Preliminary Drainage Study

Circle K Store

Project Number: 2022-00073

Approved as noted:

SAN BERNARDINO COUNTY				
CIRCLE K STORE HYDROLOGY MAP PROPOSED CONDITION				
DRAWN BY: D.R.	DATE: 07/05/2023	SCALE: AS SHOWN	SHEET: 1 OF 1	JOB NO. 210249

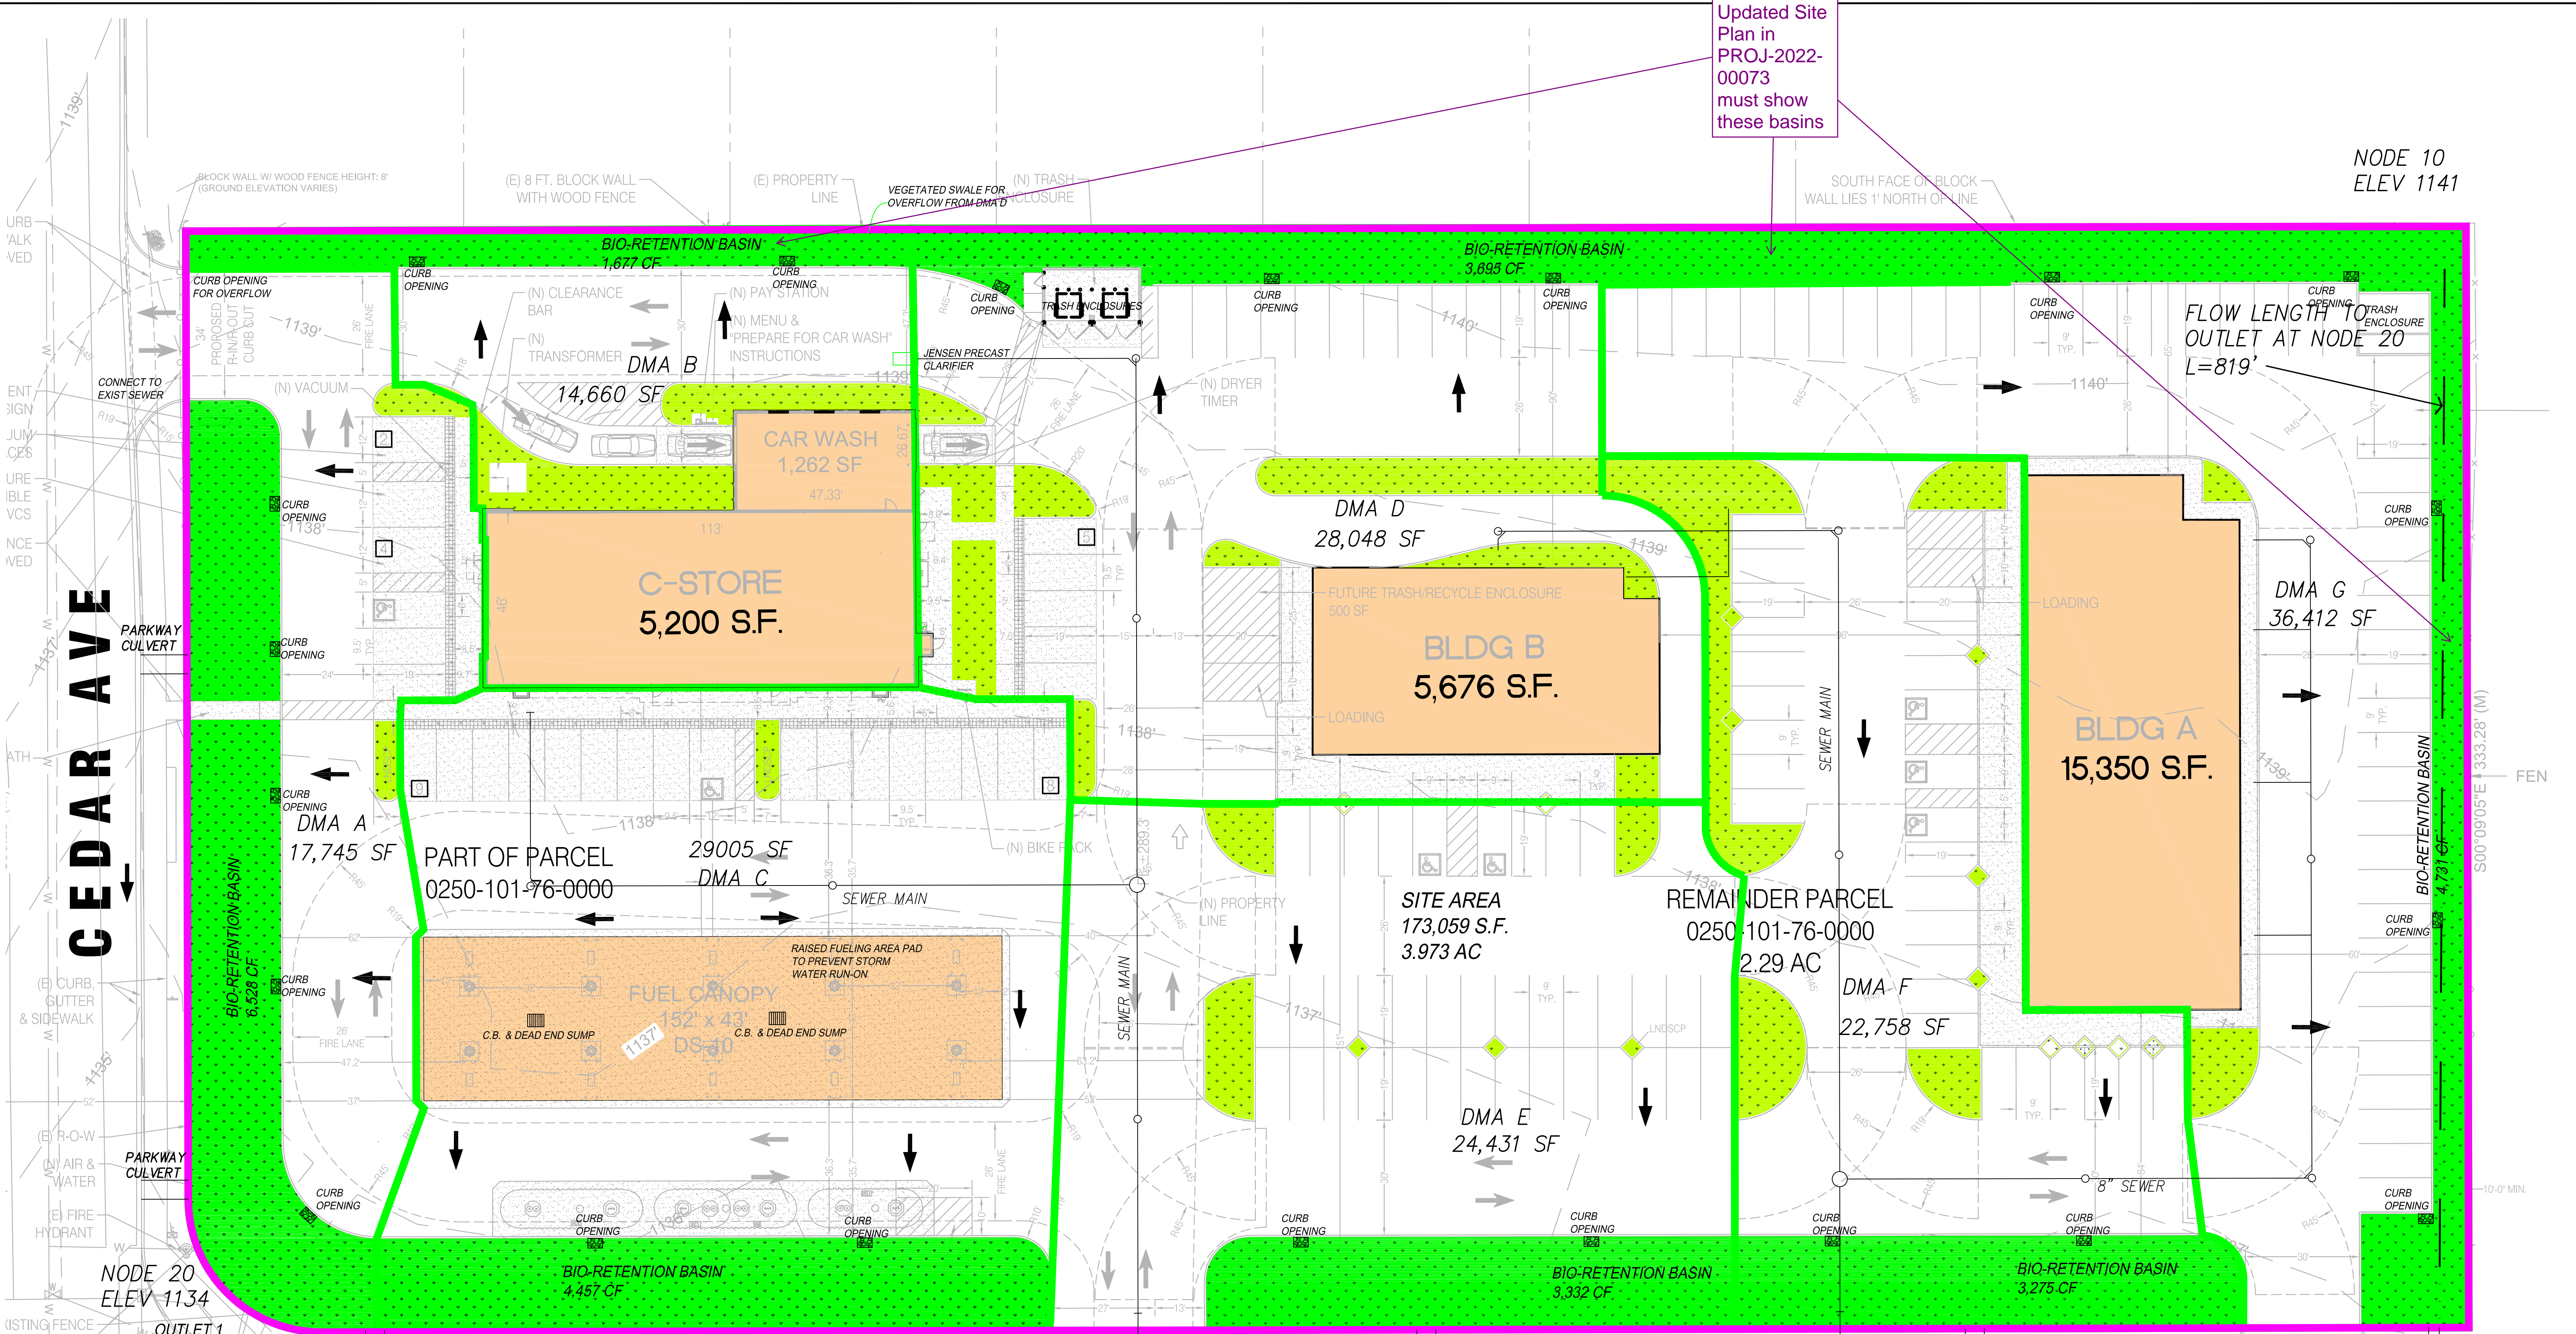
Updated Site Plan in PROJ-2022-00073 must show these basins

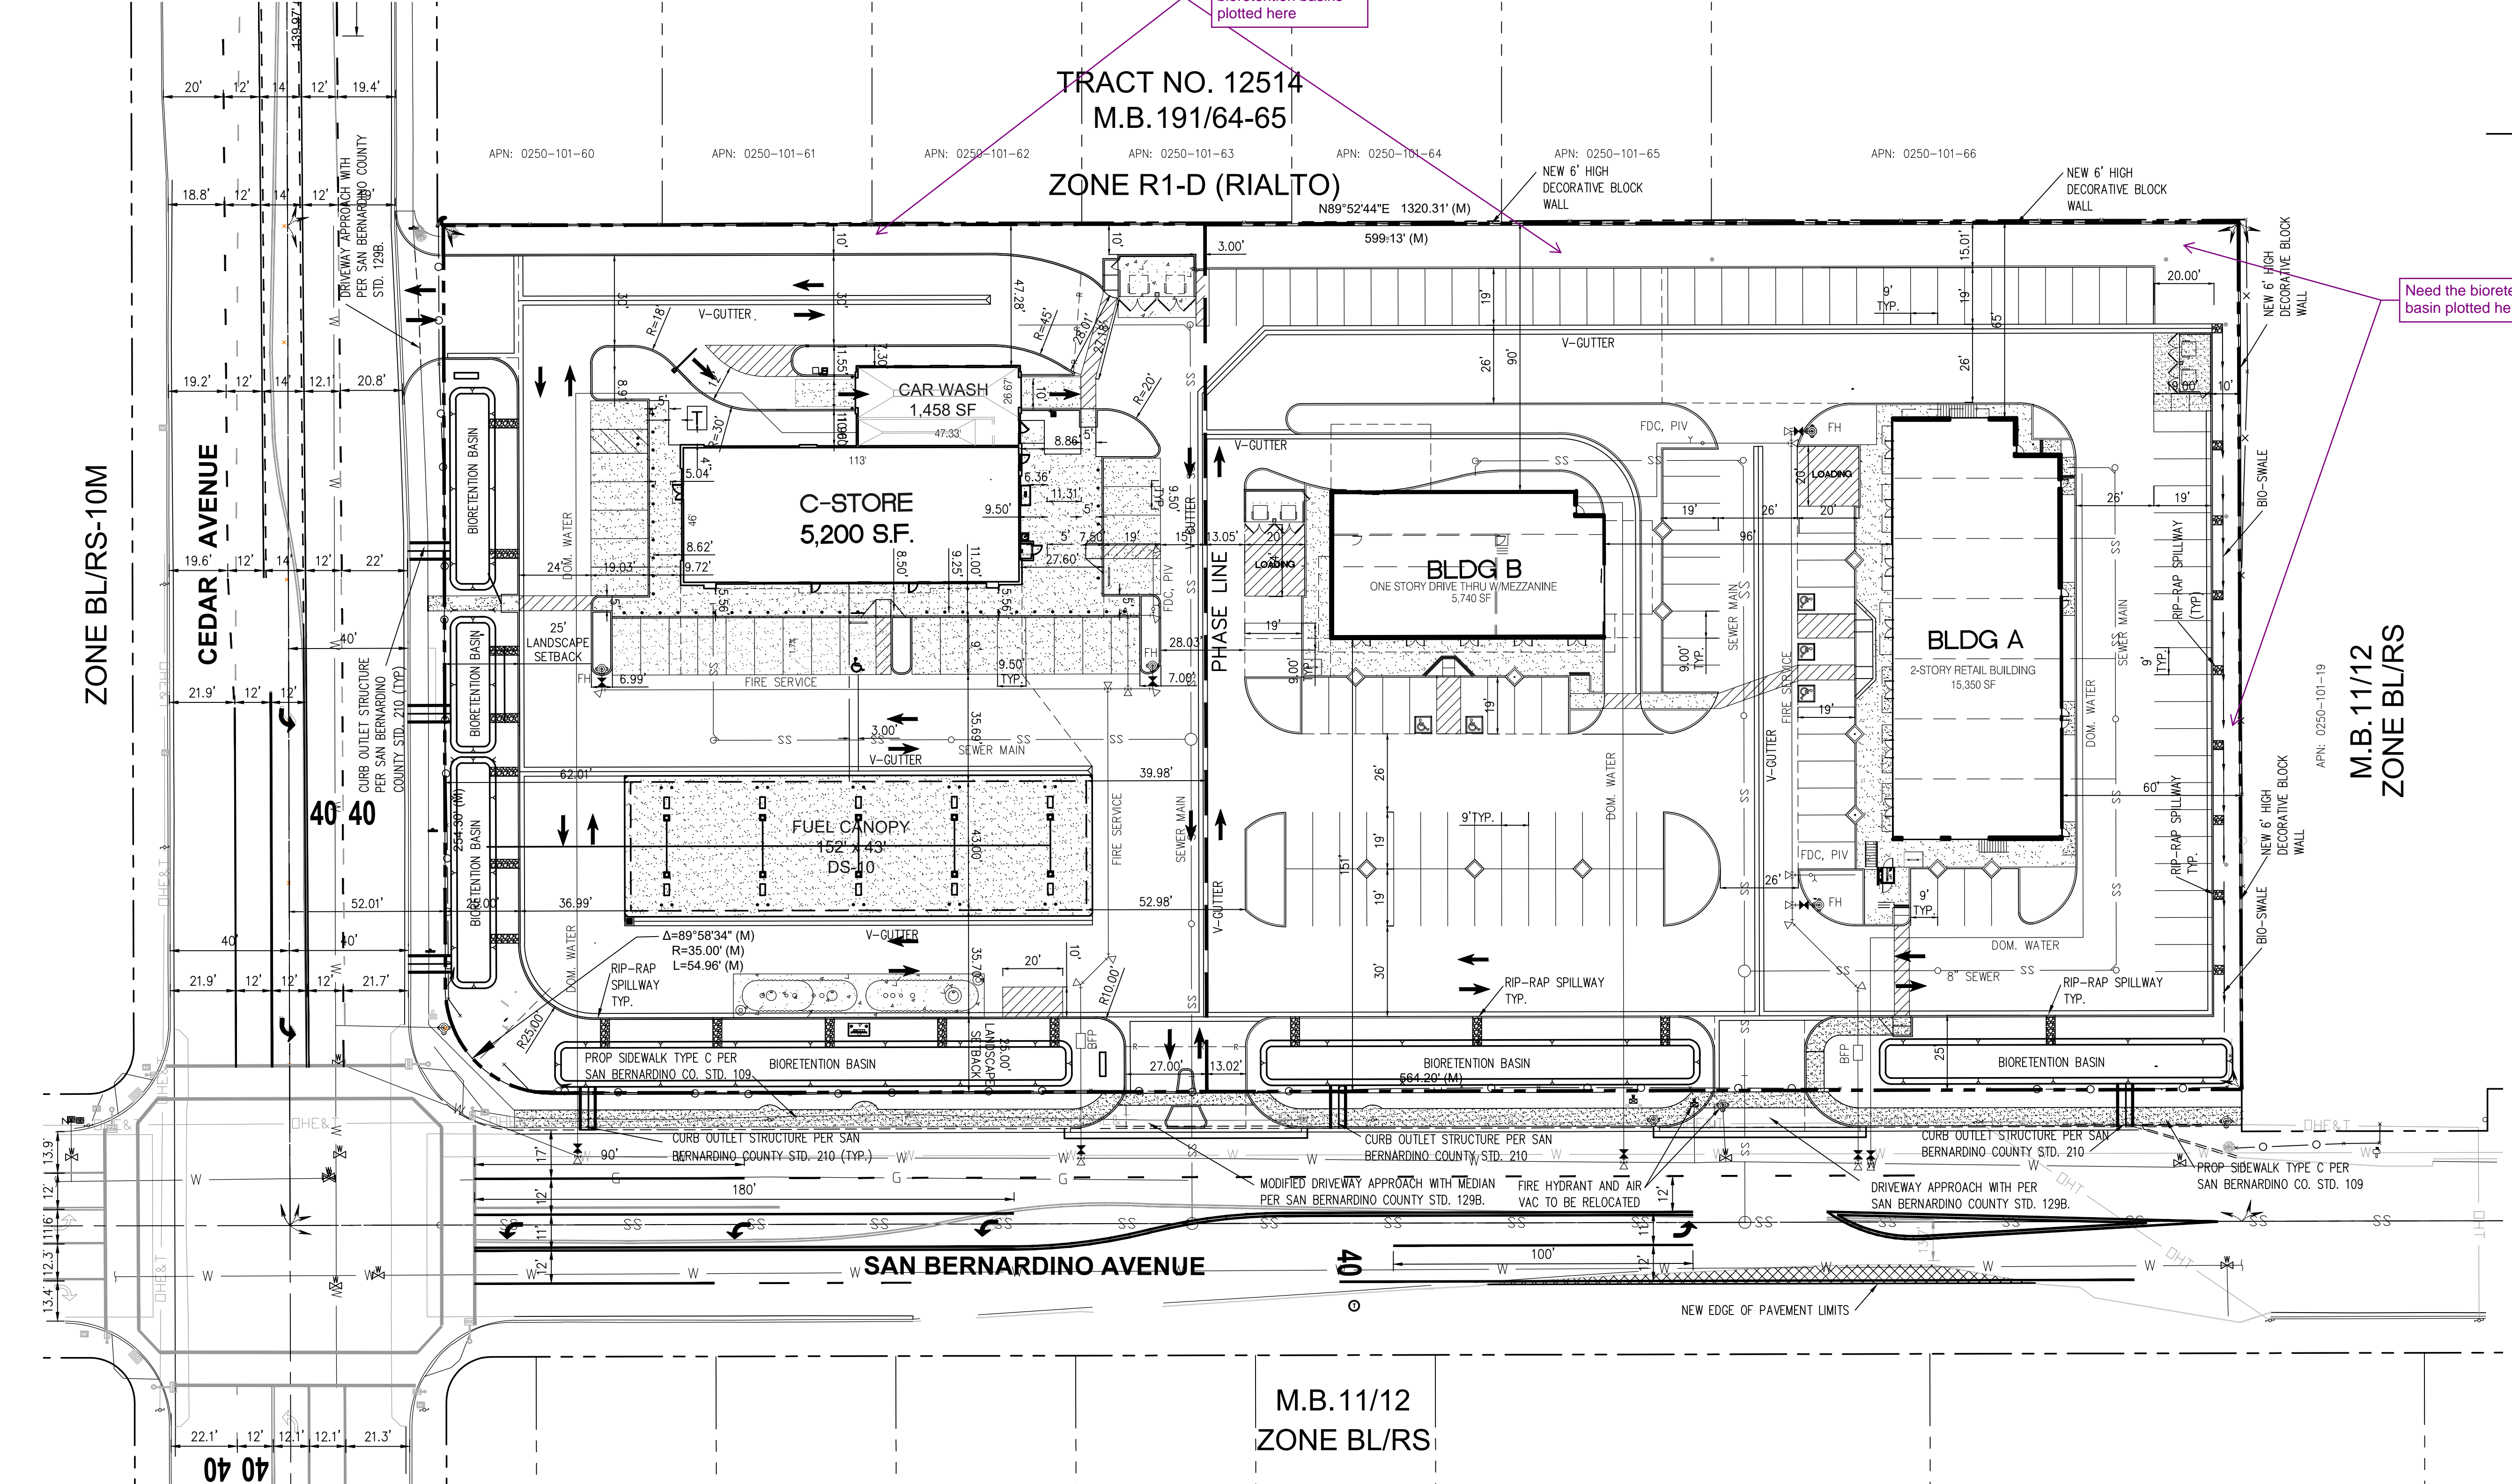
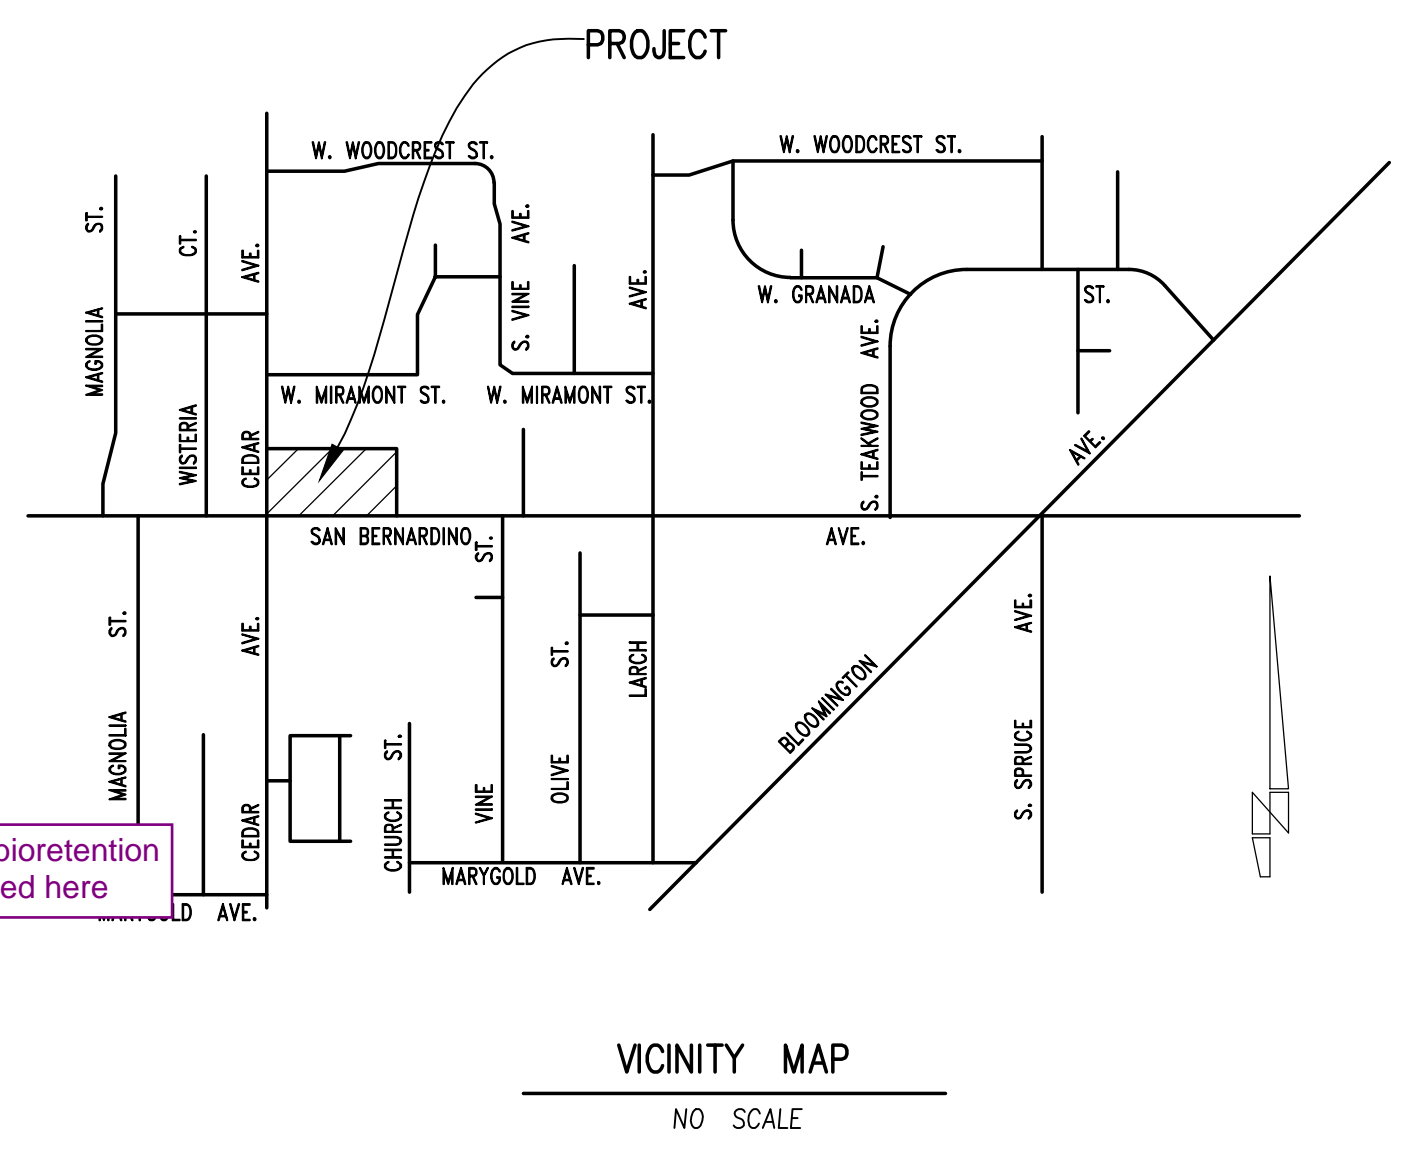
Need the bioretention basin plotted here

Need the bioretention basin plotted here
